STAFF REPORT

To: Edgerton Planning Commission
Fr: Kenneth A. Cook, Community Development Director
Re: Application FS2016-03 for the Final Site Plan for Logistics Park Kansas City
Phase IV, Second Plat, Lot 4 (IP XXXIII)

Final Site Plans Logistics Park Kansas City Phase IV, Second Plat, Lot 4 (Inland Port XXXIII)

OVERALL FLOOR PLAN

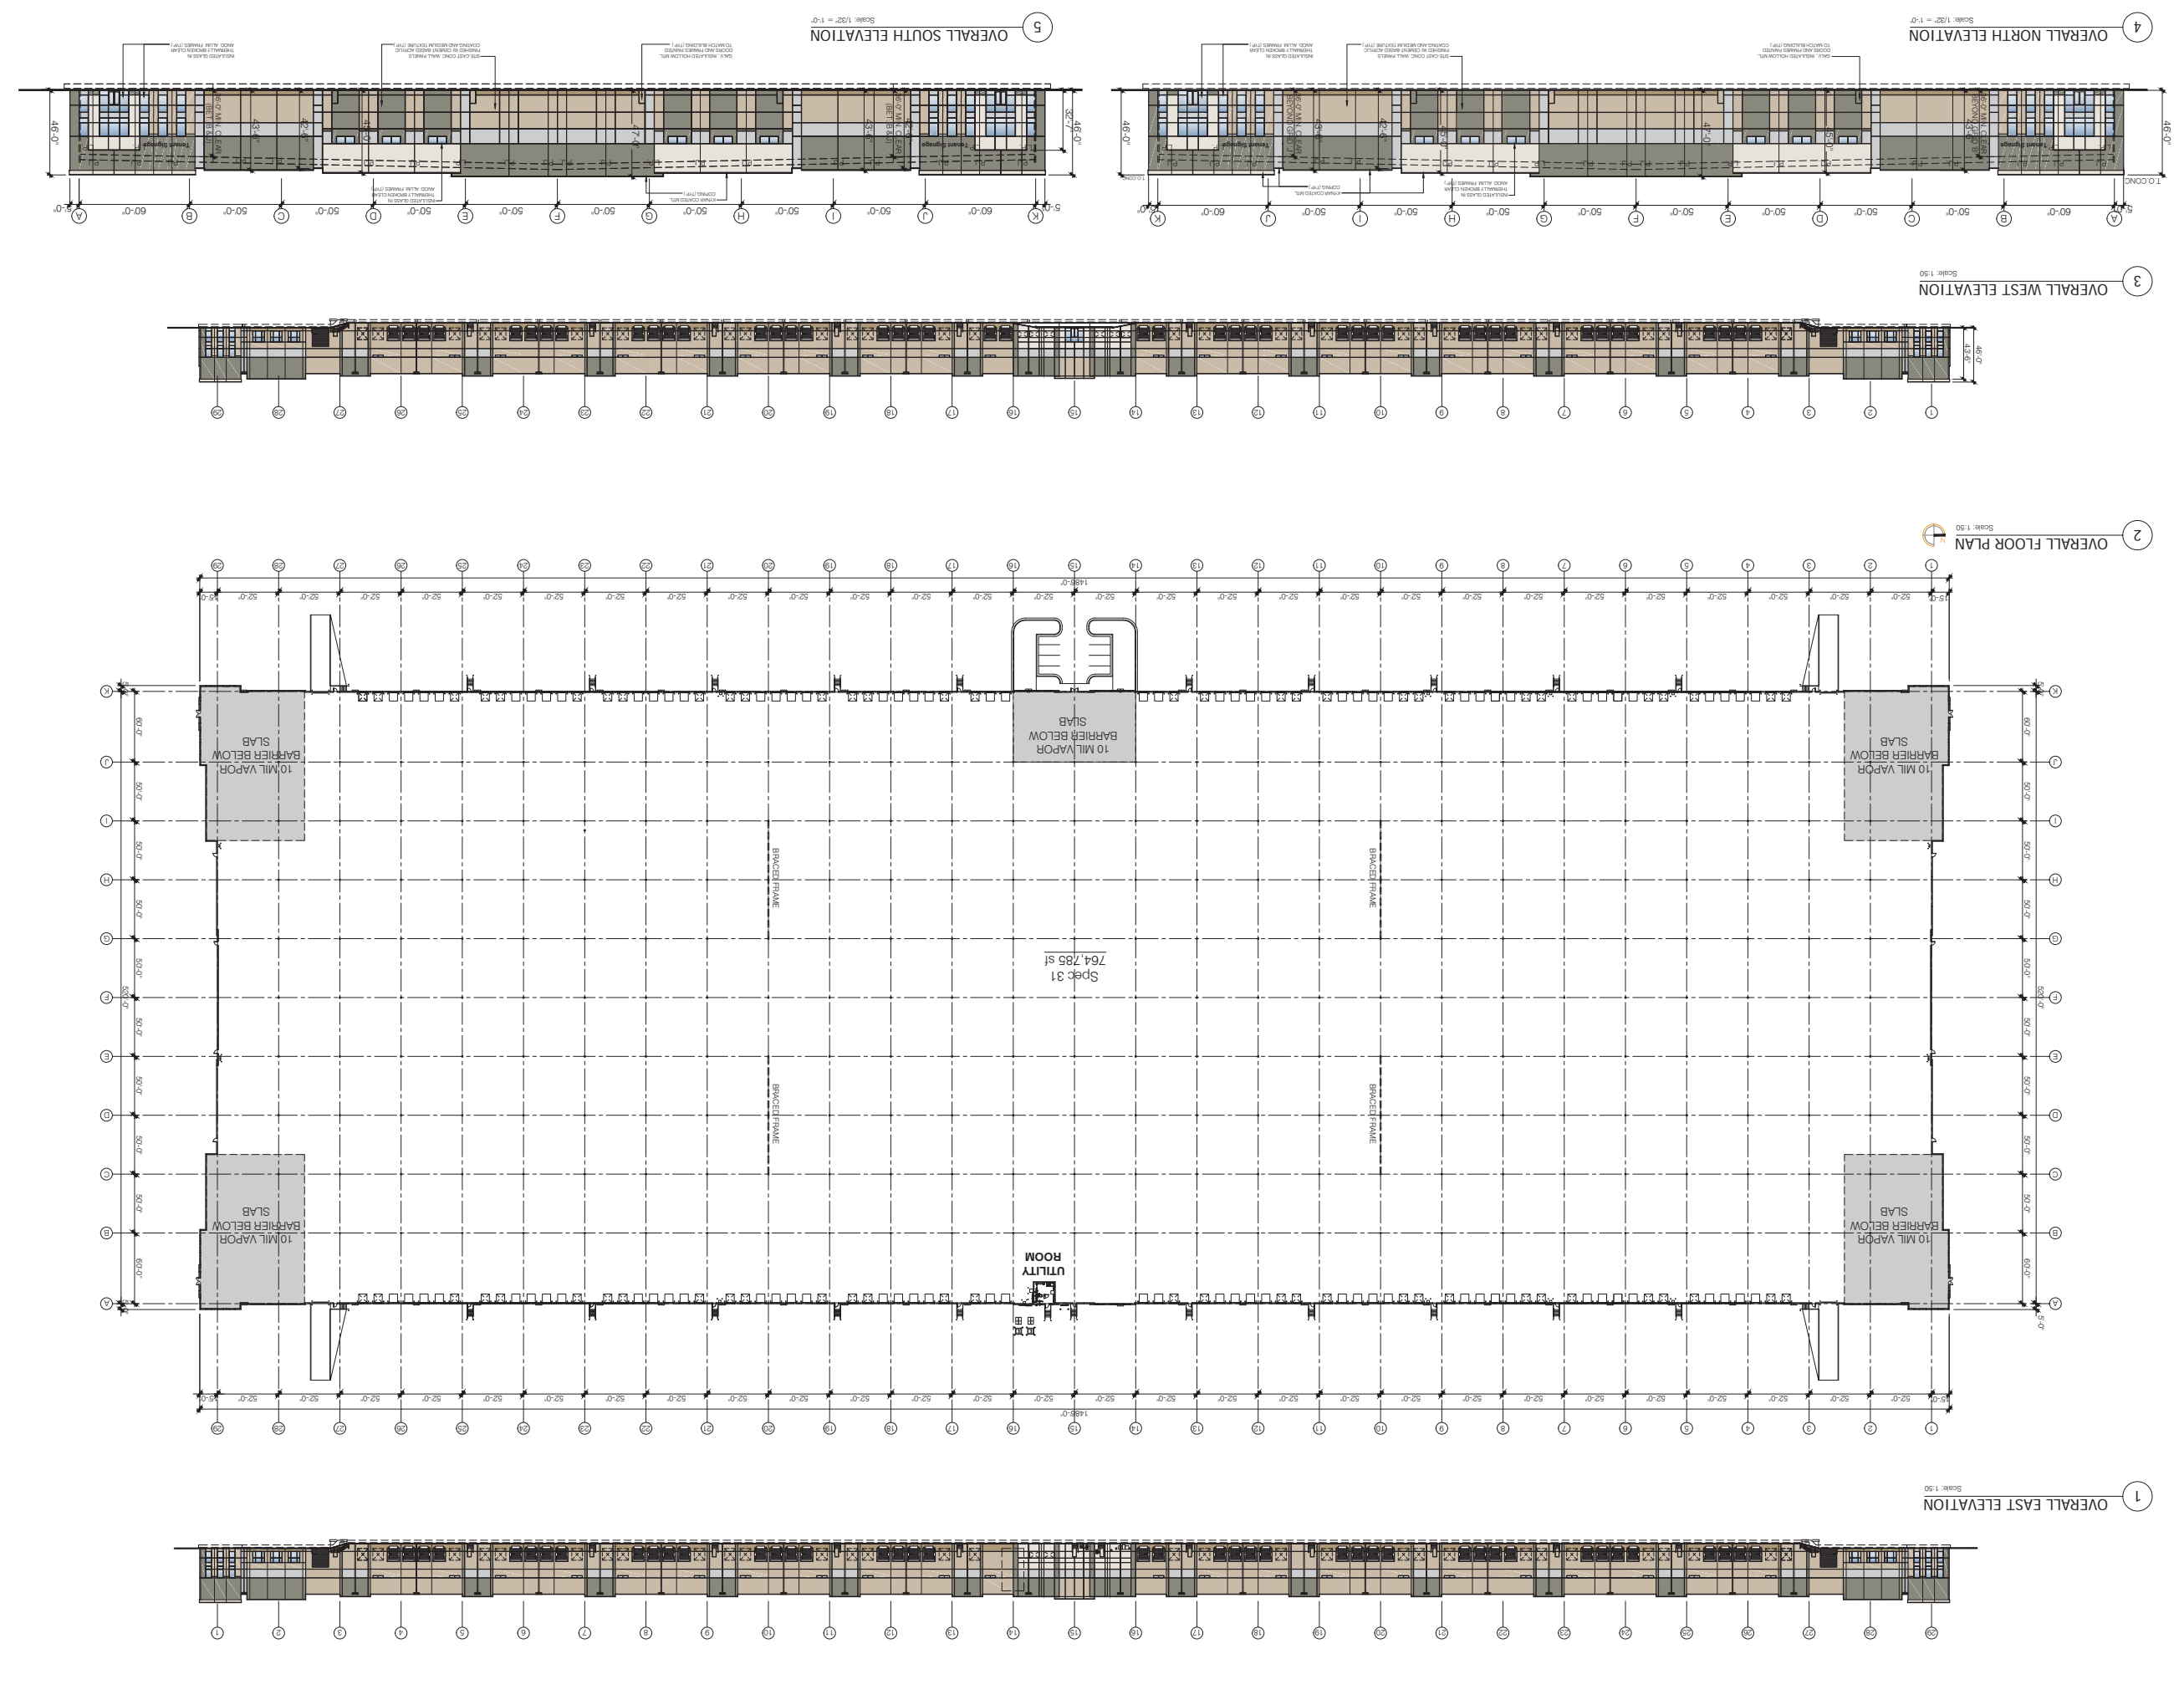
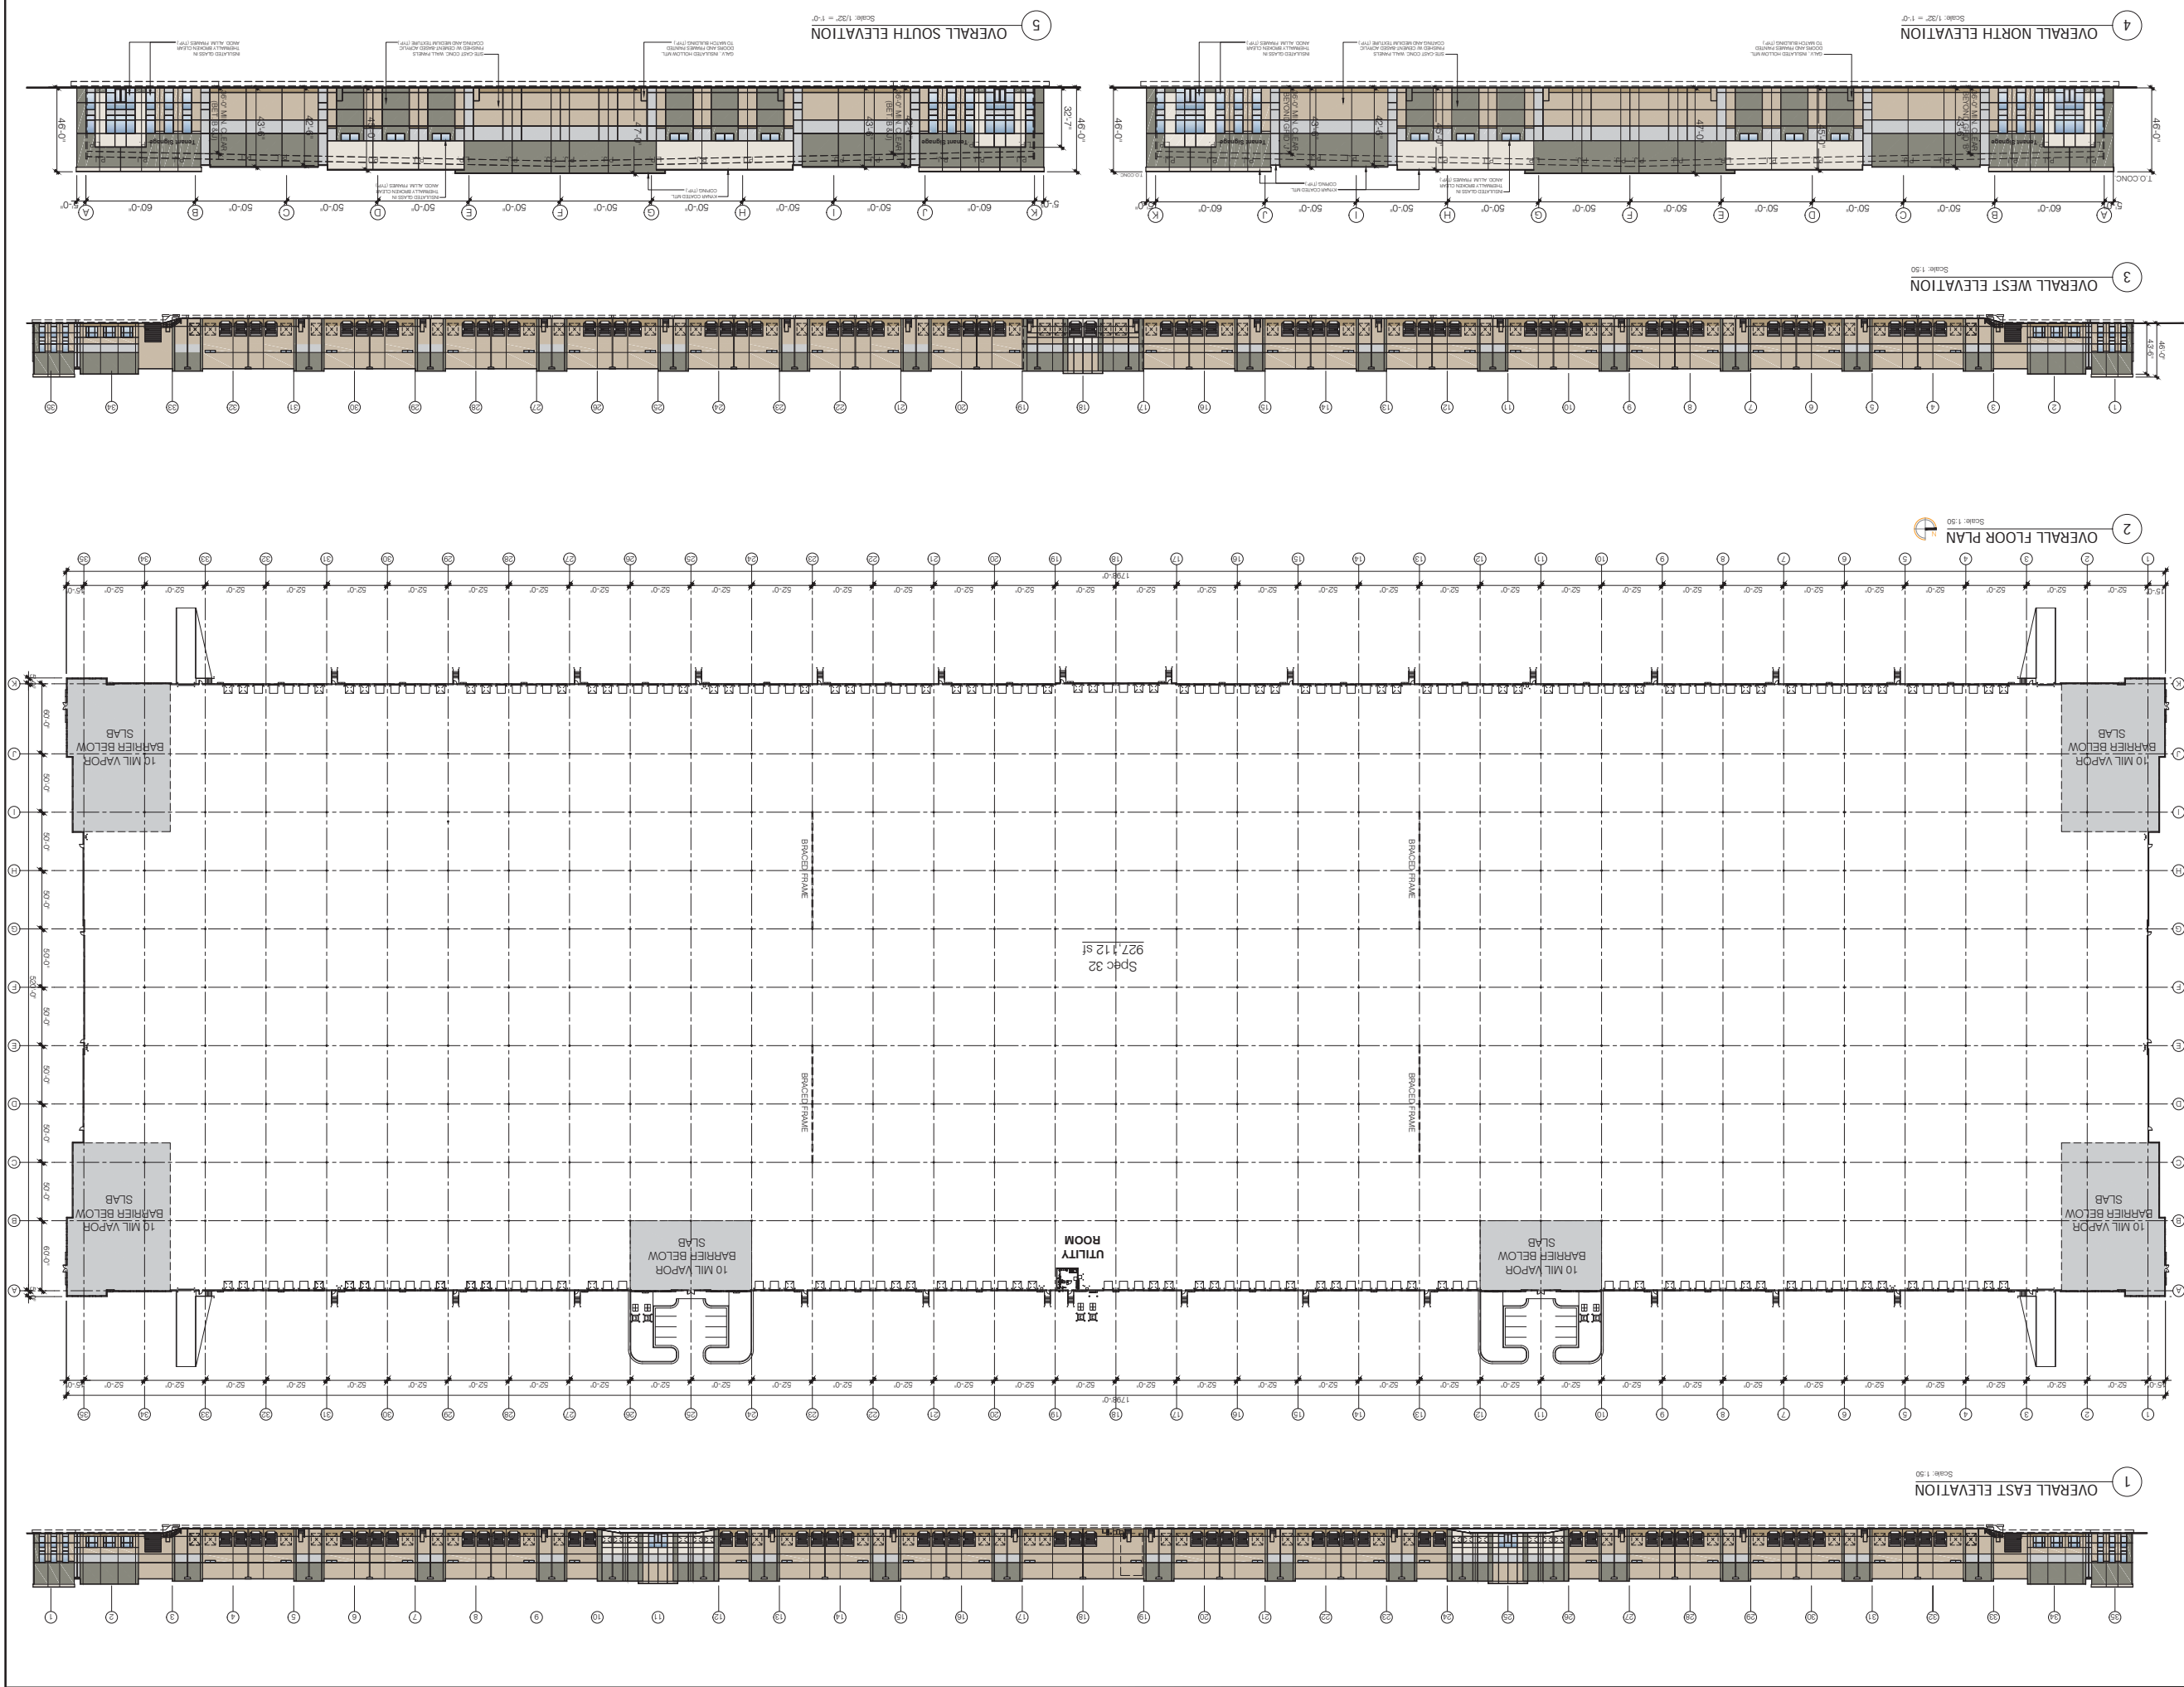
- a) Scale drawing of building floor plans. *The Inland Port numbers currently shown on the*

*overall floor plan of the building are incorrect. These plans do not currently include interior improvements as the building is being constructed speculatively. **Will be reviewed at Building Permit Review.***

- a) Scale drawings of all building elevations. *The elevations are shown on the same plans with the overall building floor plans and include the wrong Inland Port numbers. **Update Final Site Plan.***
- b) Roof pitch and materials. ***Will be reviewed at Building Permit Review.***
- c) Siding type and materials, including fascia. ***Final Site Plan complies***
